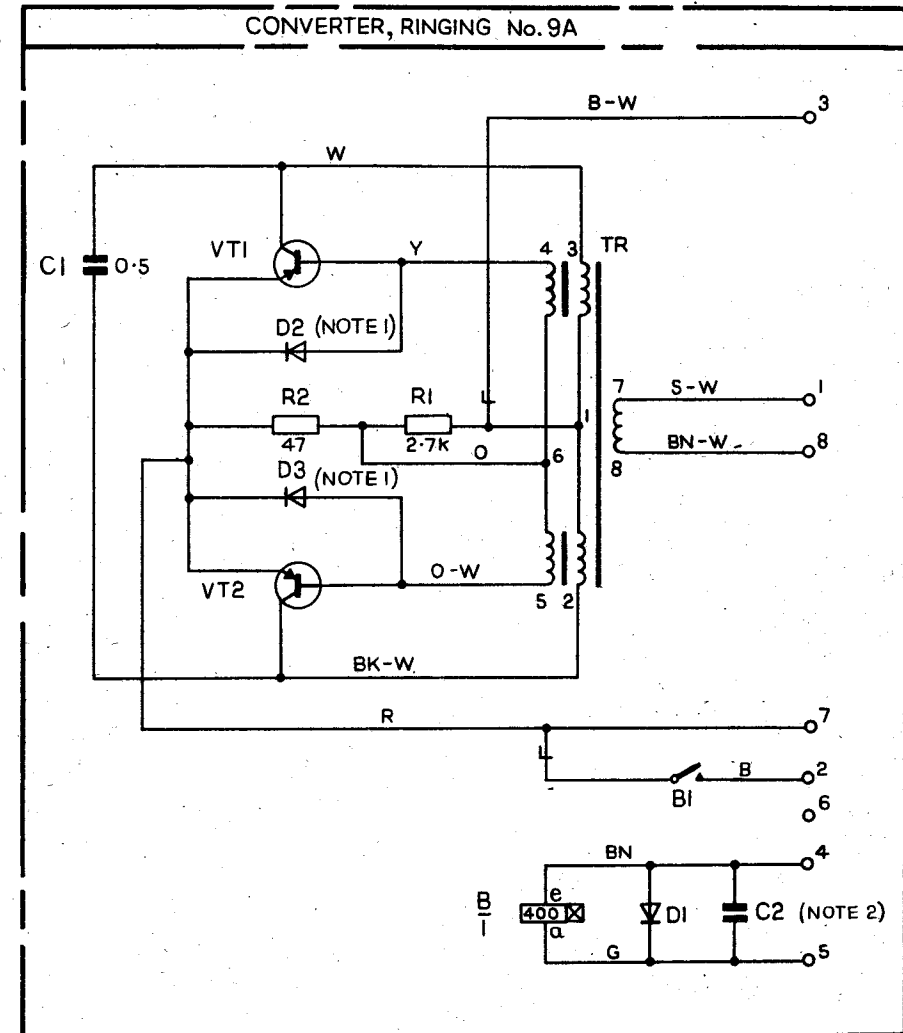
PO TELECOMMS HQRS			
PAPER : W			
DISTN :-			
GENERAL			
ISSUE			
C	NEW FORMAT, NOTES 1 & 2, DIODES D2 & D3, & CAPACITOR C2 ADDED.	TD 7.1.1	30-1-75
B	NEW FORMAT, VT1 & 2 WERE CV 7074. DI WAS CV 448 S.A.H.W		6-11-67

1. DIODES D2 AND D3 ARE ONLY FITTED ON LATER ISSUES OF CONVERTER, RINGING No.9A MARK 2.
2. CAPACITOR C2 IS NOT FITTED ON EARLIER ISSUES OF CONVERTER, RINGING. IF INTERFERENCE FROM A POWERFUL RADIO TRANSMITTER IS EXPERIENCED ON INSTALLATIONS WHERE THIS CAPACITOR HAS NOT BEEN PROVIDED BY THE MANUFACTURER, CAPACITOR No.8017B, 0.1 μ F 250V, SHOULD BE REQUISITIONED AND FITTED.
